NUMBER	REV	DATE	TITLE
DCN - #0188	0	05/06/94	DCN TITLE: **ADD PAD MOUNTED GEAR TO PRIMARY 13.8 KV FEEDER FOR OAB/TOB BLDG.** "APPROVED FOR CONSTRUCTION"

US DEPARTMENT OF ENERGY
HANFORD WASTE VITRIFICATION PLANT

DESIGN CHANGE NOTICE

DCN - 0188	REV 0	PAGE 1 OF 13
DCN TITLE ADD PAD MOUNTED GEAR TO PRIMARY 13.8 kV FEEDER FOR OAB/TOB BLDG		DATE INITIATED 05/05/94
		PACKAGE NO. A170

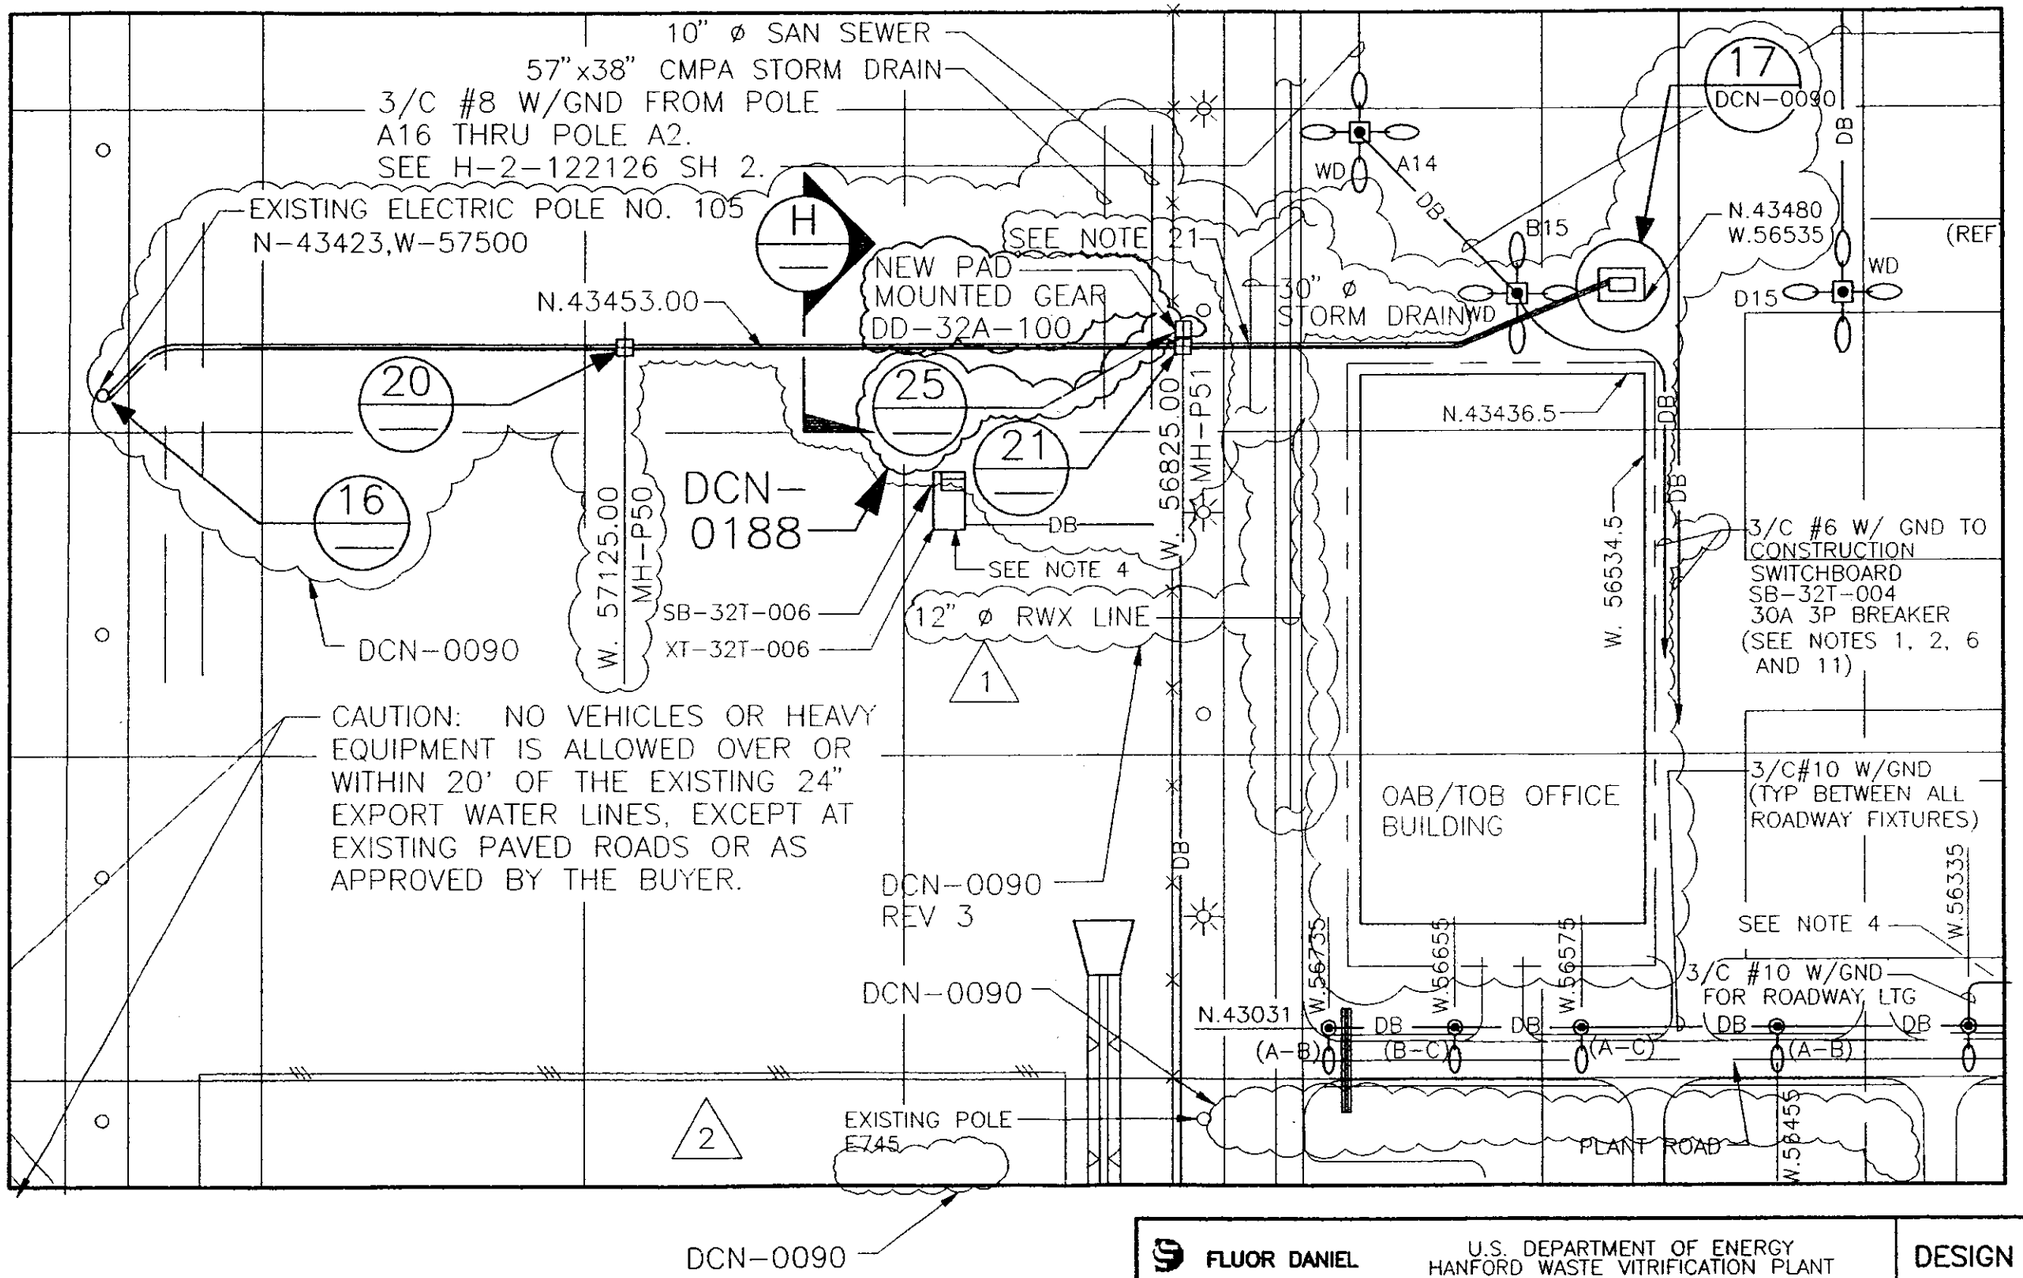
DOCUMENT NUMBER	SHT/ PAGE	REV NO	DOCUMENT NAME	INCLD Y/N	DESCRIPTION OF CHANGE
SPECIFICATION B-595-C-A170 -16111 ATTACHMENT A	1,2	0	CONDUIT SCHEDULE	Y	ADDED CONDUITS TO & FROM MH-P51 TO PAD MOUNTED GEAR
ATTACHMENT B	1	0	CABLE SCHEDULE	Y	ADDED CABLES TO PAD MOUNTED GEAR
H-2-122126	1	3	ELECTRICAL CONSTRUCTION UTILITIES OVERALL DISTRIBUTION PLAN	Y	ADDED PAD MOUNTED GEAR
H-2-122134	1	3	ELECTRICAL CONSTRUCTION UTILITIES DETAILS	Y	ADDED CONDUIT ENTRANCE TO MH-P51. REVISED ONE LINE. ADDED INSTALLATION DIAGRAM
H-2-122134	3	3	ELECTRICAL CONSTRUCTION UTILITIES DETAILS	Y	ADDED PAD WITH STUB-UPS FOR PAD MOUNTED GEAR

NEW PAD MOUNTED GEAR
INSTALLATION DIAGRAM

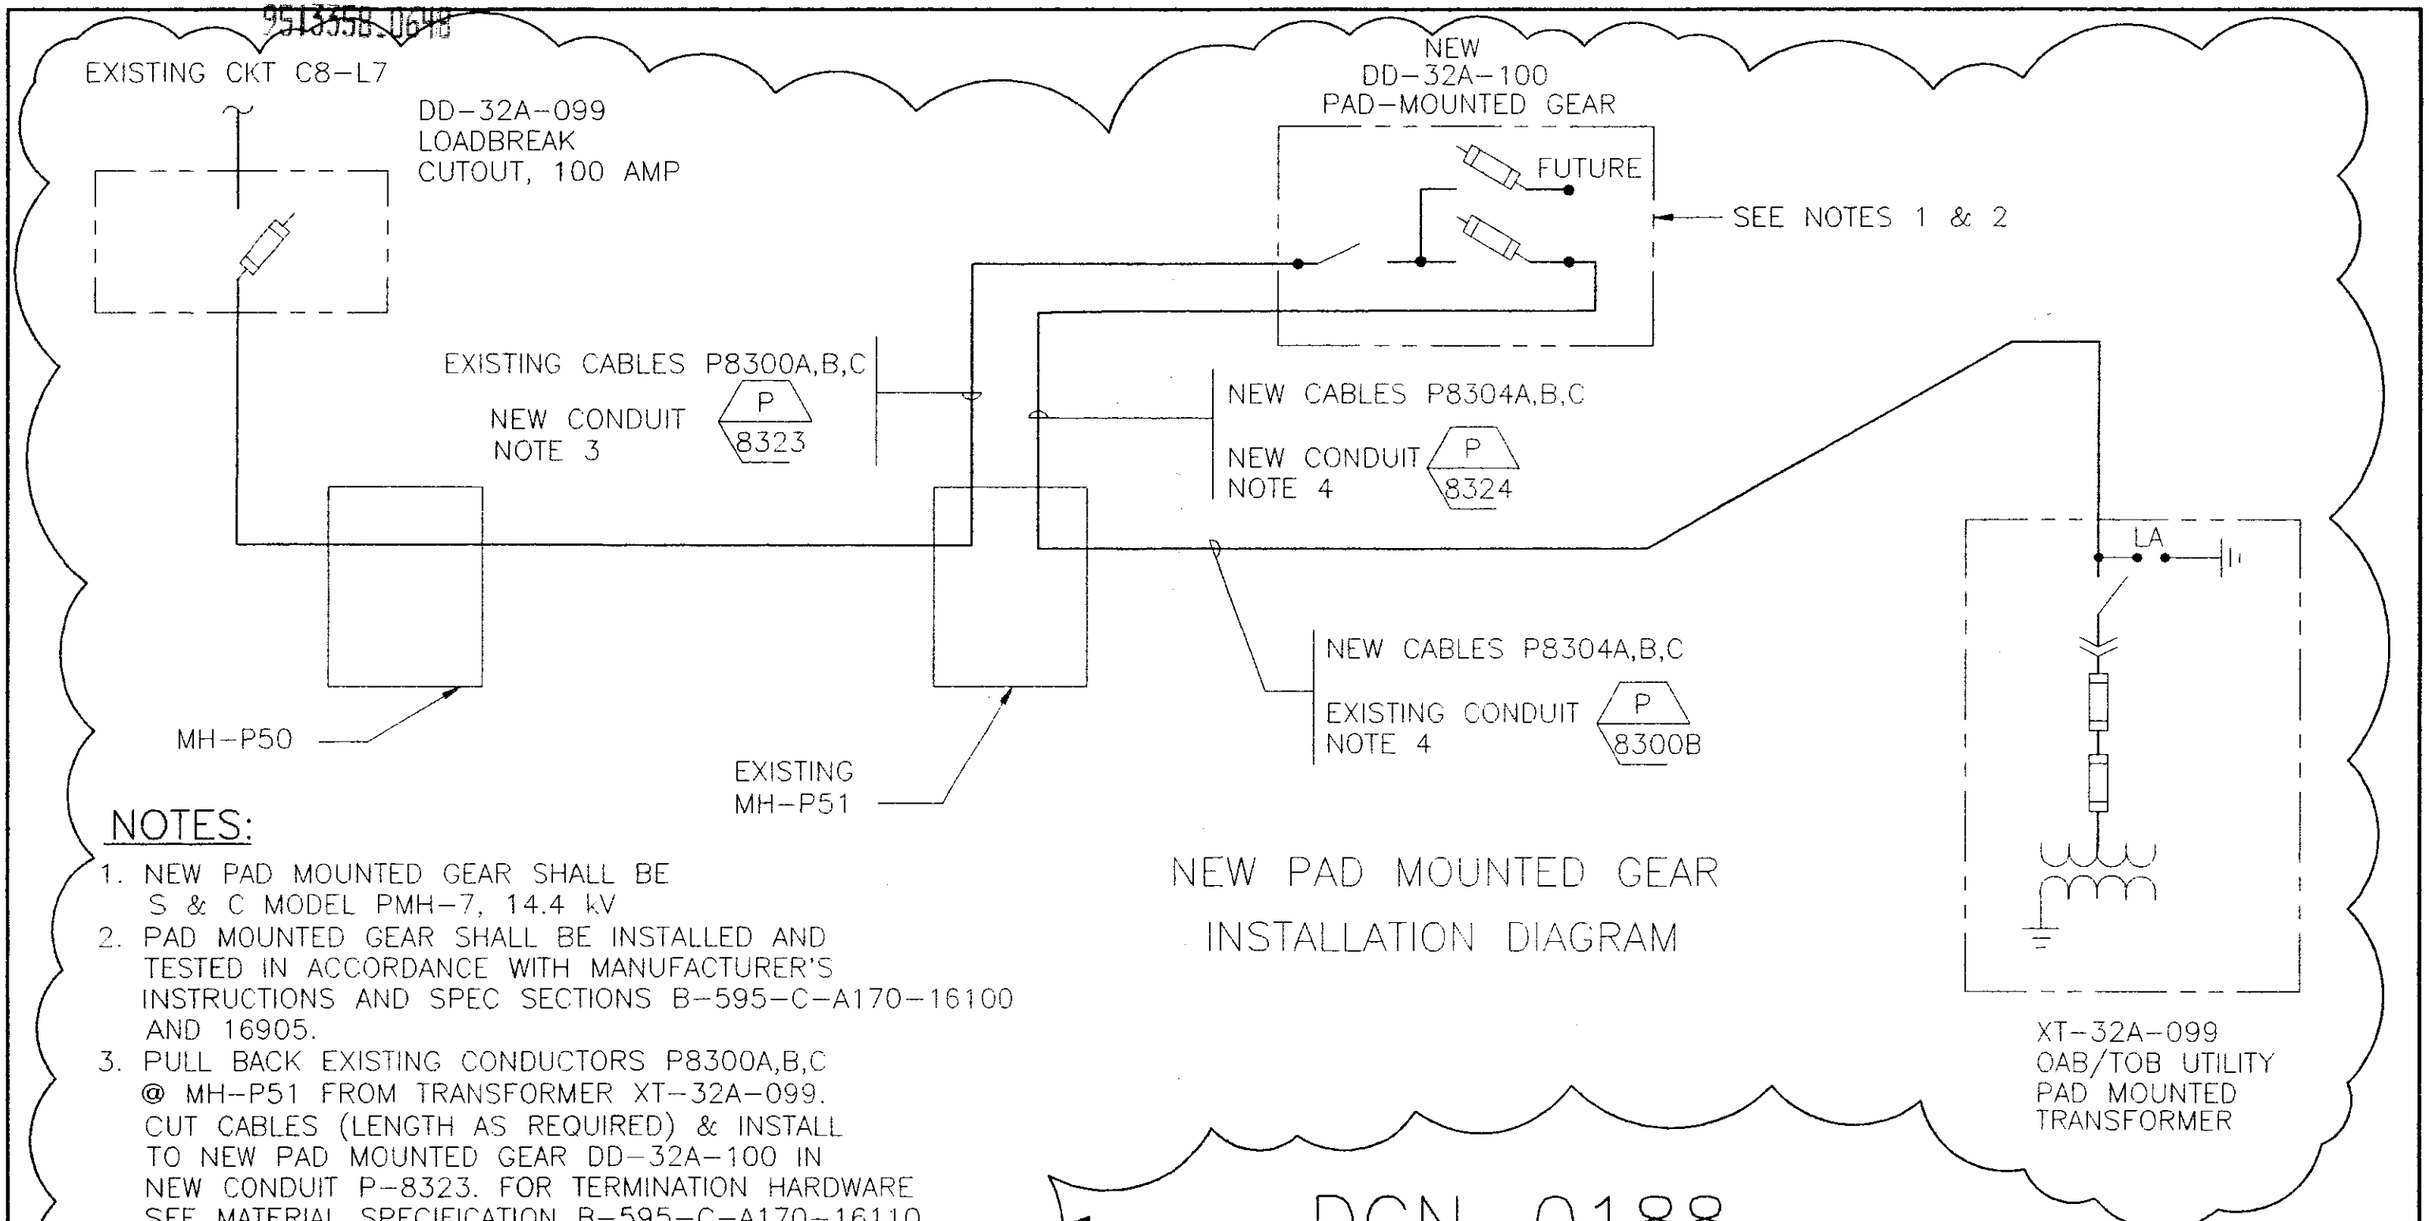
1. NEW PAD MOUNTED GEAR SHALL BE S & C MODEL PMH-7, 14.4 kV
2. PAD MOUNTED GEAR SHALL BE INSTALLED AND TESTED IN ACCORDANCE WITH MANUFACTURER'S INSTRUCTIONS AND SPEC SECTIONS B-595-C-A170-16100 AND 16905.
3. PULL BACK EXISTING CONDUCTORS P8300A,B,C @ MH-P51 FROM TRANSFORMER XT-32A-099. CUT CABLES (LENGTH AS REQUIRED) & INSTALL TO NEW PAD MOUNTED GEAR DD-32A-100 IN NEW CONDUIT P-8323. FOR TERMINATION HARDWARE SEE MATERIAL SPECIFICATION B-595-C-A170-16110.
4. INSTALL NEW CONDUCTORS P8304A,B,C FROM NEW PAD MOUNTED GEAR DD-32A-100 TO TRANSFORMER XT-32A-099 VIA MANHOLE MH-P51
5. CONDUIT & CABLE INSTALLATION SHALL BE PER SPECIFICATION B-595-C-A170-16100.
6. CONDUCTORS P8300A,B,C AND P8304A,B,C SHALL BE TESTED AFTER INSTALLATION IN ACCORDANCE WITH SPECIFICATION SECTION B-595-C-A170-16905.

DETAIL 20

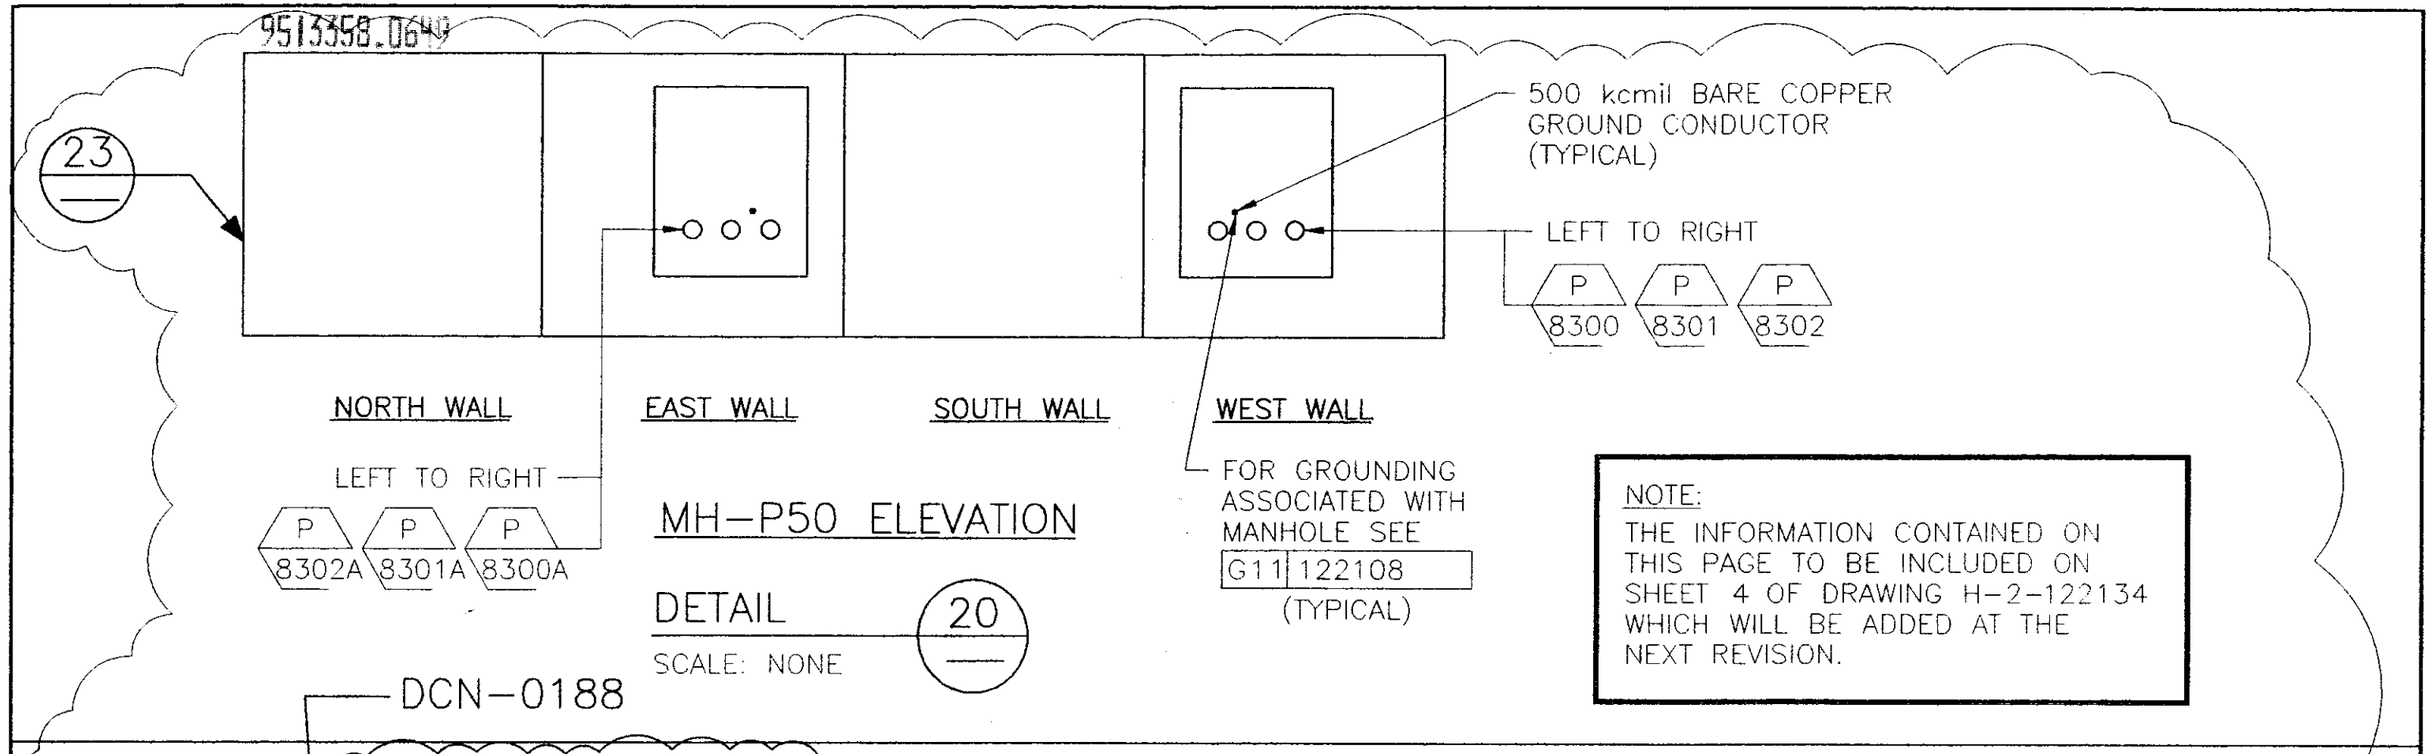
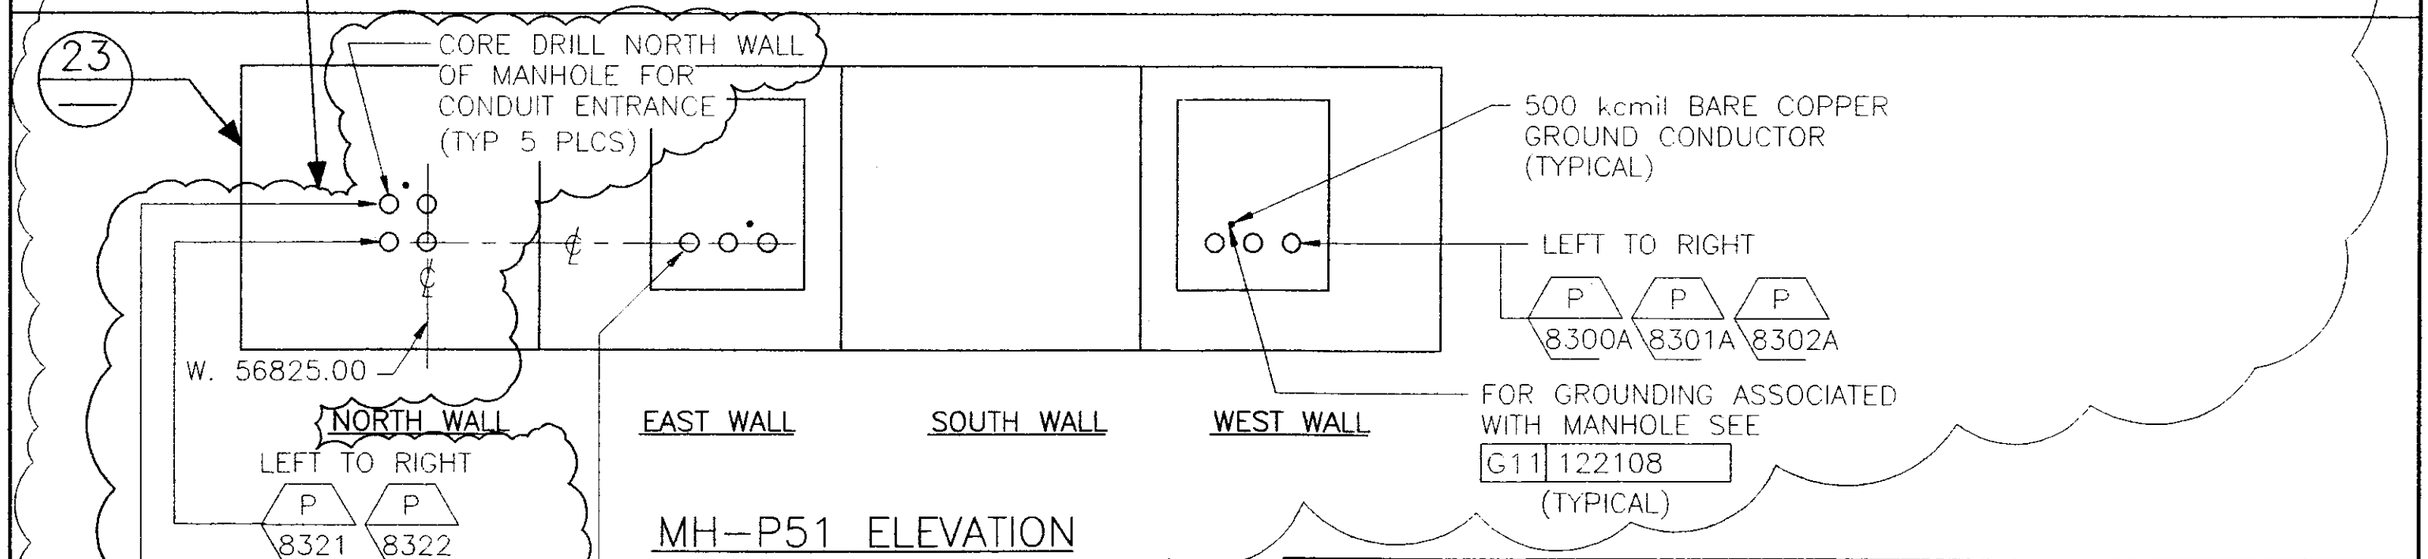
NOTE:
THE INFORMATION CONTAINED ON THIS PAGE TO BE INCLUDED ON SHEET 4 OF DRAWING H–2–122134 WHICH WILL BE ADDED AT THE NEXT REVISION.
